PROJECT: Sheep Mountain Pkwy at Skyc Canyon

SUBMITTAL: 2nd

CITY OF LAS VEGAS INTER-OFFICE MEMORANDUM				DATE: June 20, 2018
TO: **Land Development Services** Department of Building & Safety				FROM: Albert Sung, P.E. Flood Control Project Engineer Department of Public Works
SUBJECT:	Drainage Study for: **Sheep Mountain Parkway at Skye Canyon**			**COPIES TO:** Slater Hanifan Group
Cross Streets:	Grand Teton Boulevard at Puli to Iron Mountain Road			M F Land LLC / Ninety-Five Management LLC
File Number:	F:\Depot\DSMemos\DS4952B.doc			Bart Anderson, P.E., DevCo
Parcel Number:	126-12-101-002			CCRFCD
Zoning Action:	N/A			
FEMA Flood Zone	YES	NO	X	
Proposed Storm Drain	YES	NO	X

GR-04
SHEET 31 OF 50
DWG NO. _____

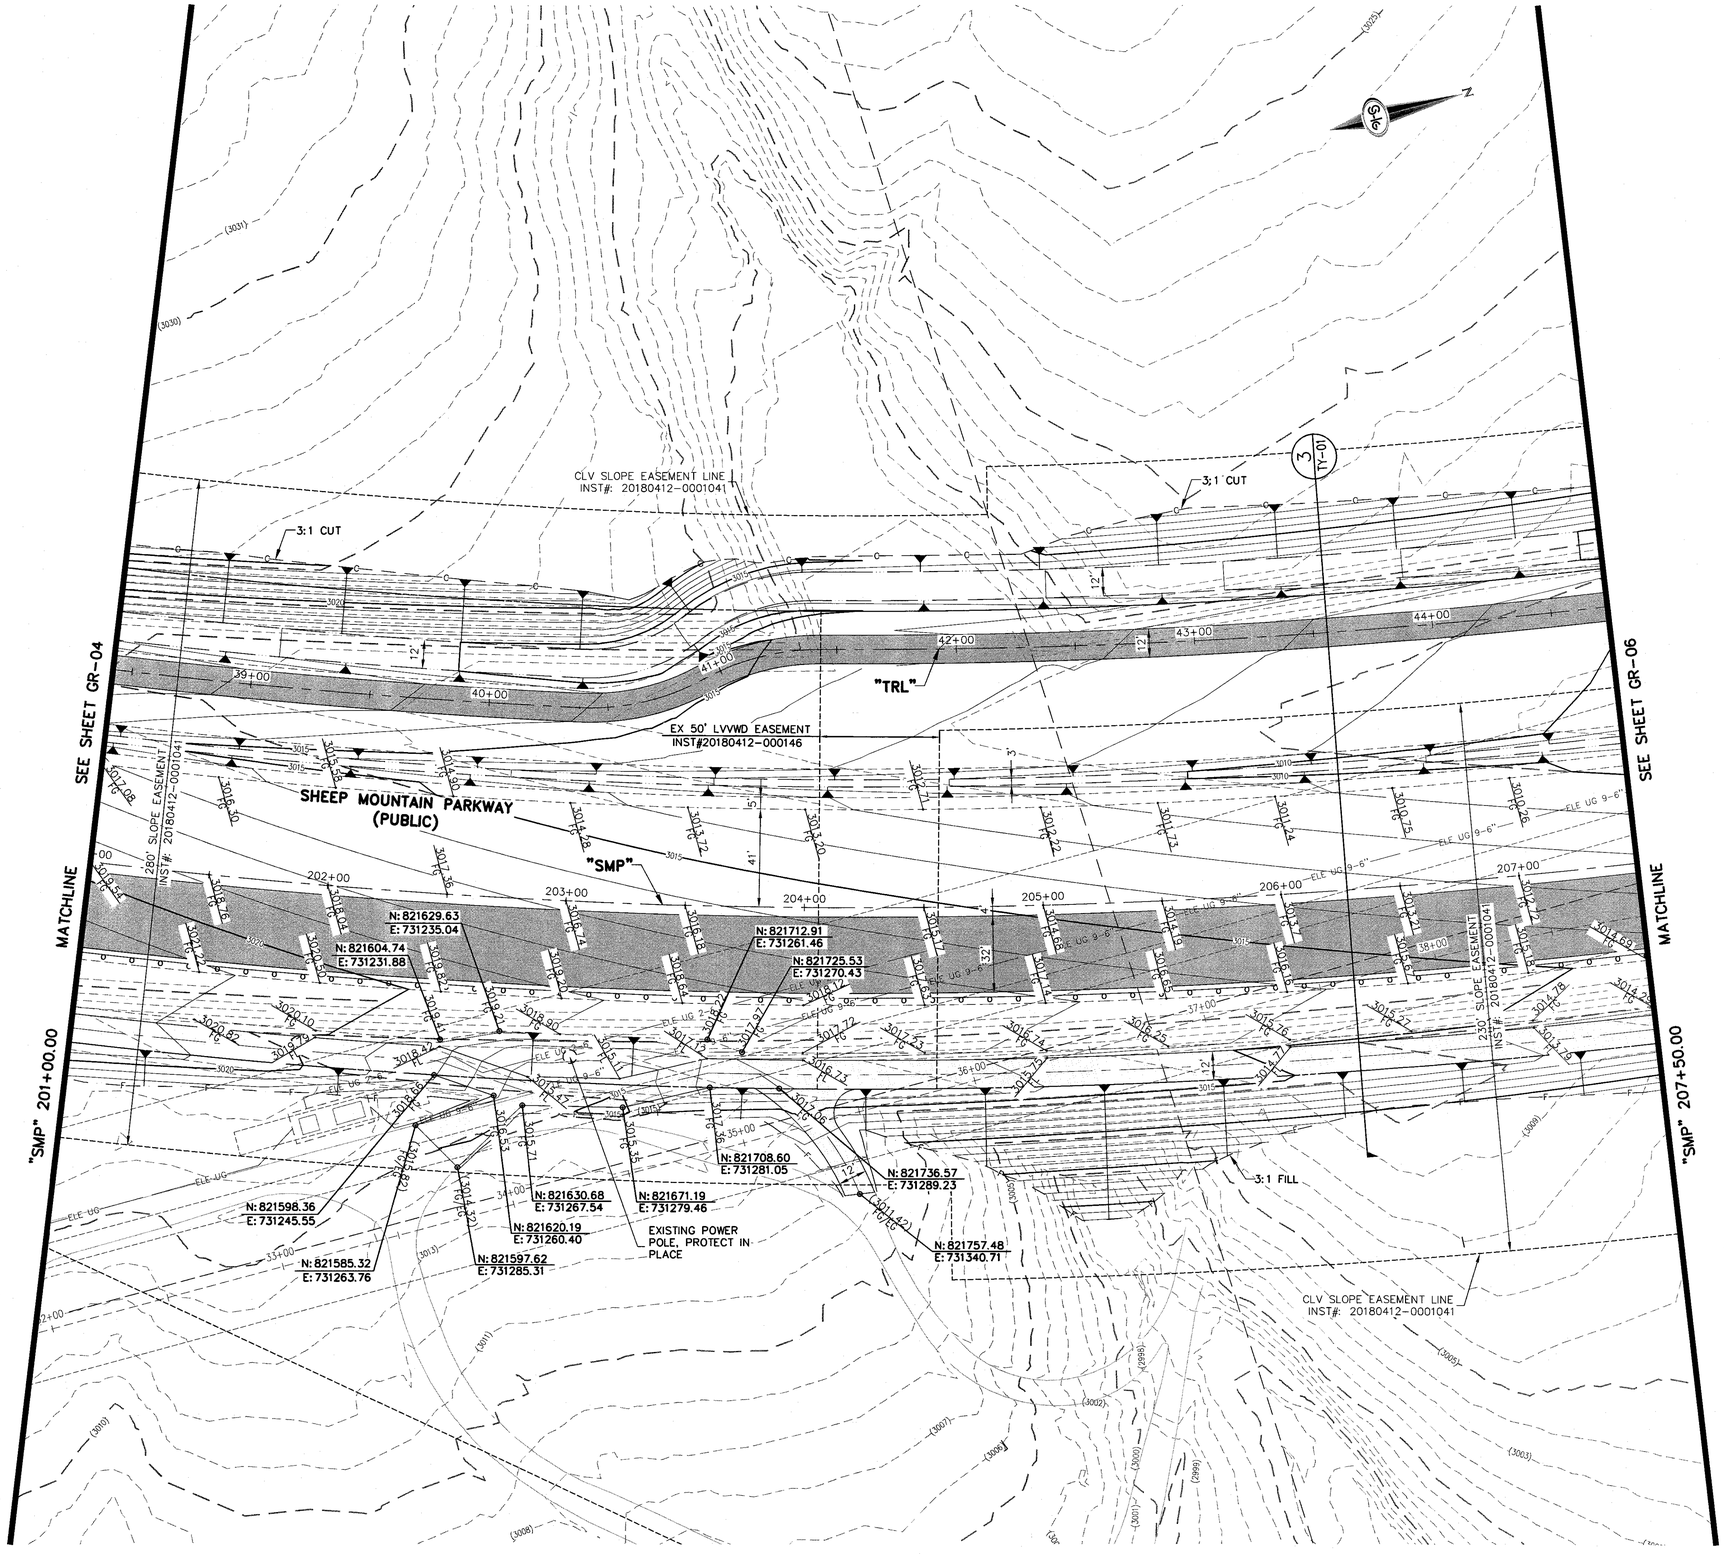
18. **Comment:** *Sheet GR-04: Construction Note #13 proposes a 3'-concrete cutoff wall to the west side of the trail. Provide cross section to reflect the wall and the related drainage facilities.*

Response: A 3-ft concrete cutoff wall was constructed in this location with the Skye Canyon Detention Basin 1 project to provide protection against a PMF spillway overtopping event. This alignment is being altered with the subject project, and although a trail facility would not typically be protected against a PMF overtopping event, this cutoff wall is being reconstructed to perpetuate the level of protection provided with the detention basin project. The cutoff wall has been shown on Lateral Profile 1 on Sheet GR-10, and the limits are called out on Sheet C-15 and C-16.

The existing DB1 outfall pipe has been shown and identified on Sheet GR-04.

GR-05
SHEET 32 OF 50

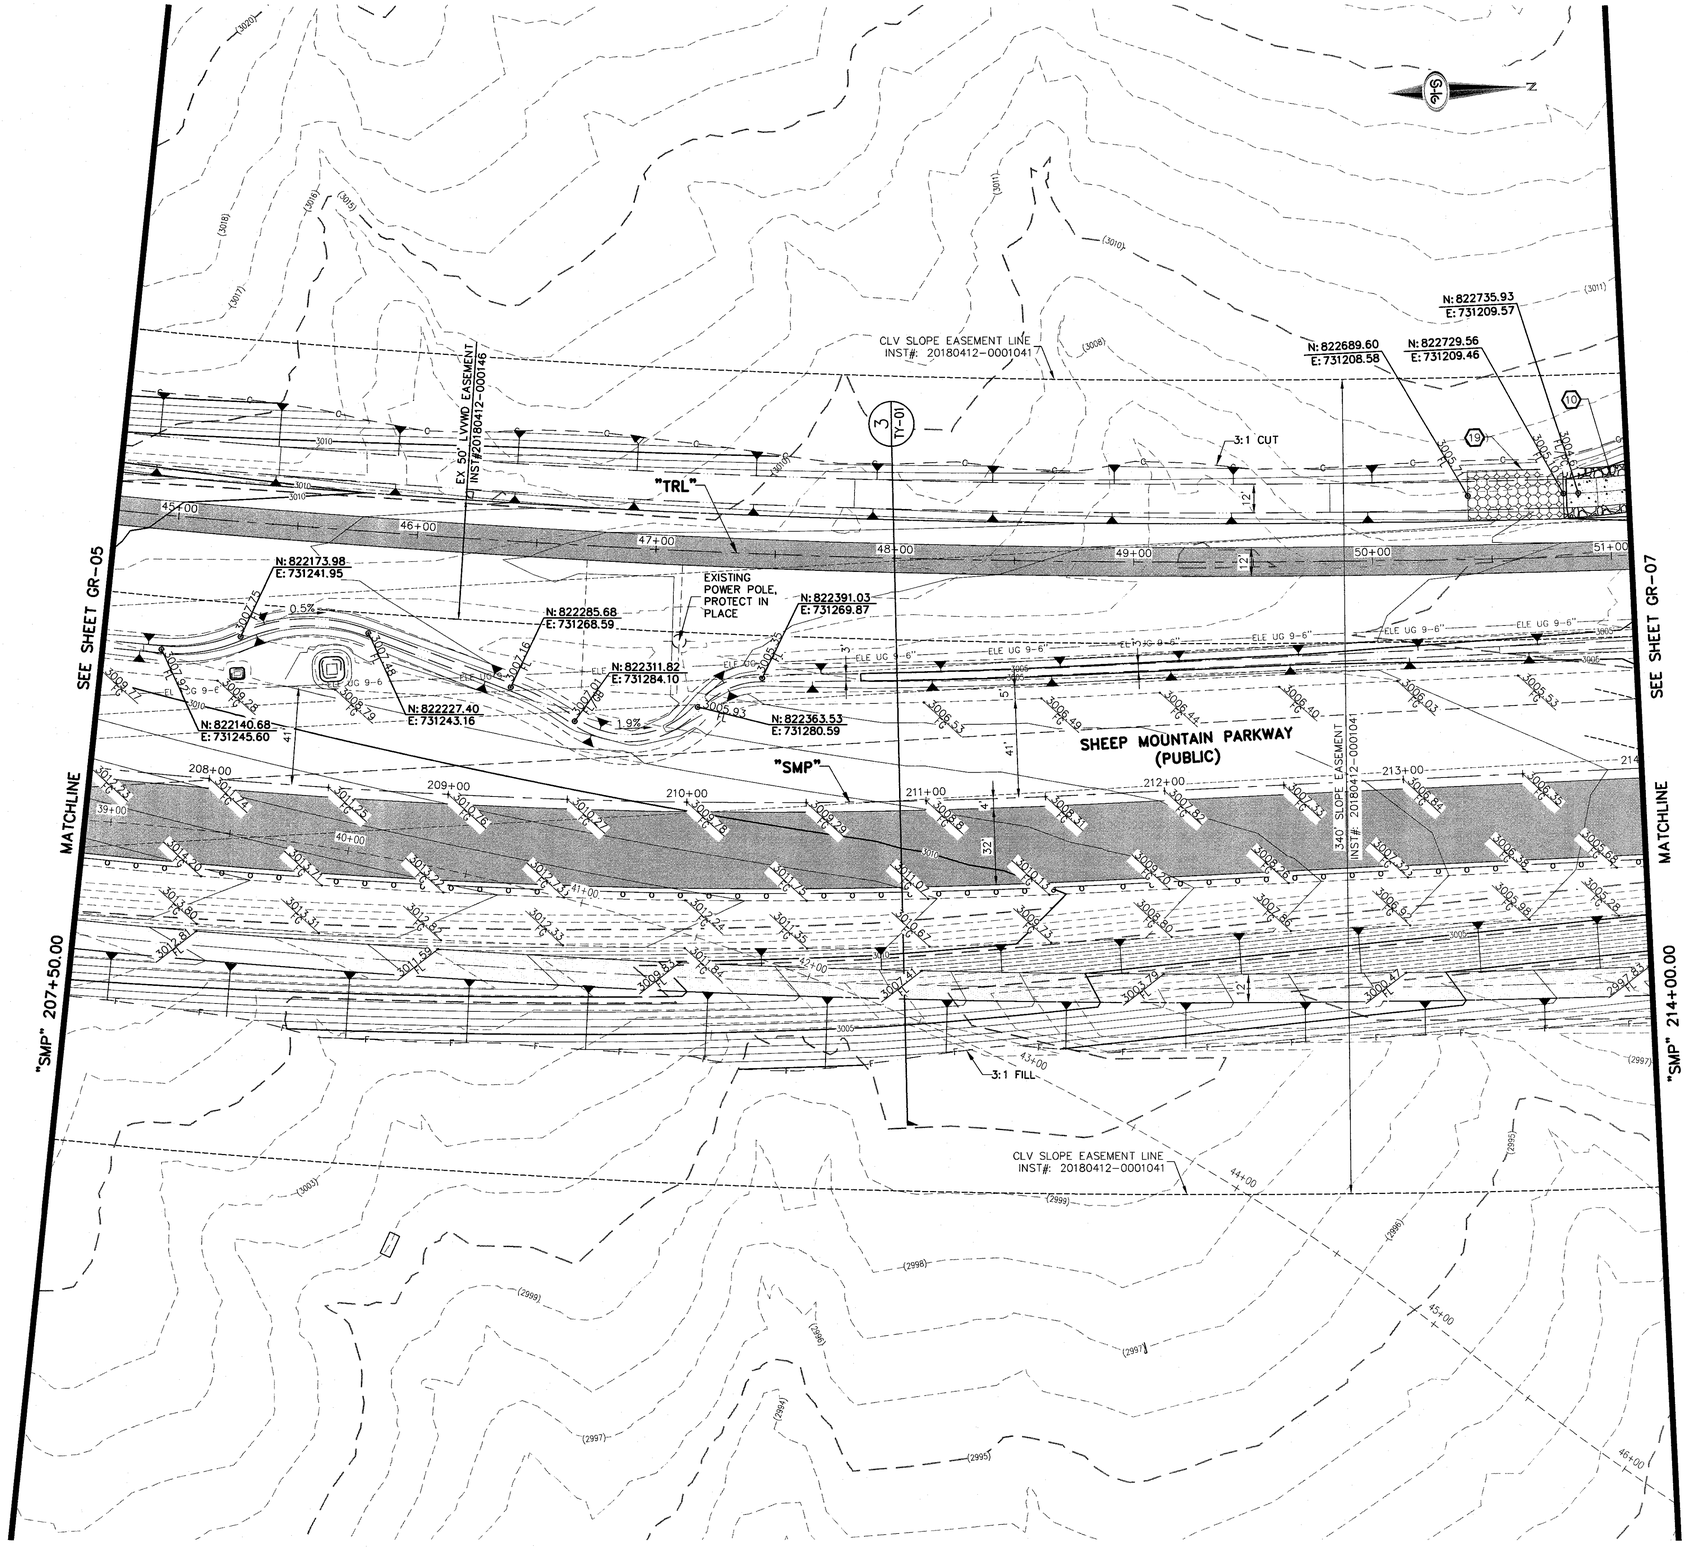
19. **Comment:** *Sheet GR-05 and Sheet GR-06: Same as in Comment #18, the roadway section on both sheets is super-elevated and not matching Detail Section 3/TY-01. Review and revise accordingly.*

GR-07
SHEET 34 OF 50
DWG NO. _____

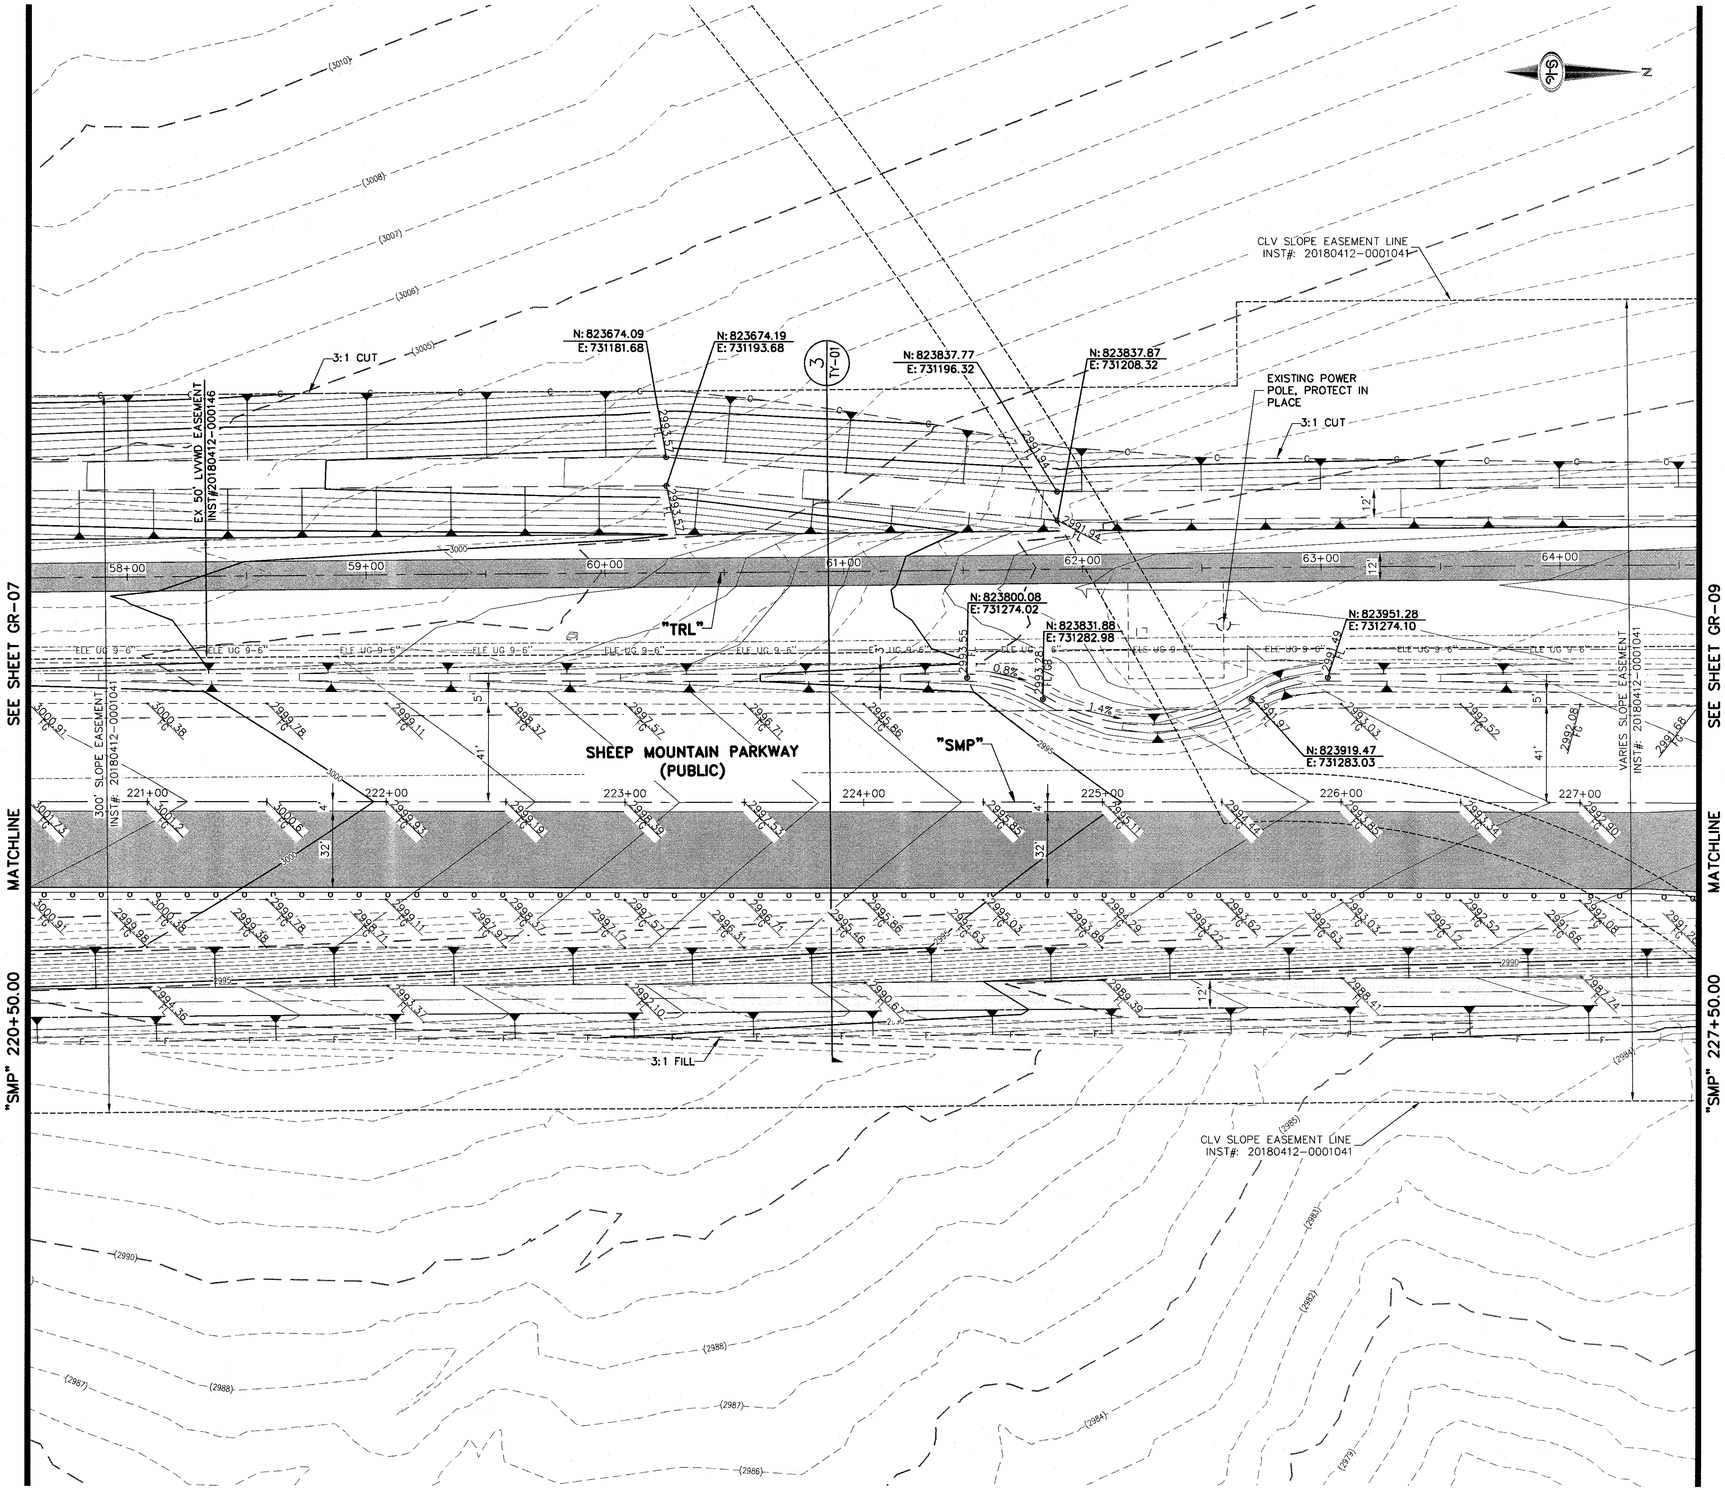
20. **Comment:** *Sheet GR-07: Construction Note #14 proposes CMP pipe which is not acceptable. Use RCP.*

Response: The 54-inch CMP culvert proposed on Sheet GR-07 has been revised to RCP. Due to the decrease in interior roughness in changing from corrugated metal to concrete, the hydraulic performance of the culvert has increased, and the size was able to be reduced to 48-inch. See Appendix C for revised HY-8 calculation.
